PERMIT
SEWAGE DISPOSAL SYSTEM
HOWARD COUNTY HEALTH DEPARTMENT
BUREAU OF ENVIRONMENTAL HEALTH
410-313-2640

P 515242-D
A 59915-T
ISSUE DATE 5/11/2001
APPROVAL DATE 5/17/01

SUBDIVISION Monticello LOT NUMBER 7 ADDRESS 1726 Oakdale Drive

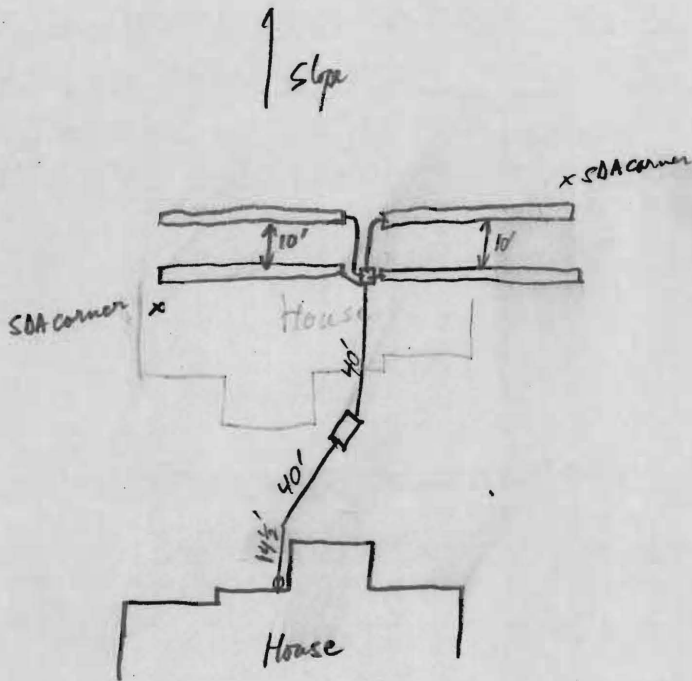
PRE-CONSTRUCTION INSPECTION: Layout OK - same as on BP Plan, AP 5/16/01

INSPECTION COMMENTS: House Connection OK, Septic Tank OK, Baffles in S.T. OK ('T'), dist Box OK, all Trenches OK, OK to Cover System when Manhole Rise + clearest @ S.T. set. R/Pirley 5/17/01
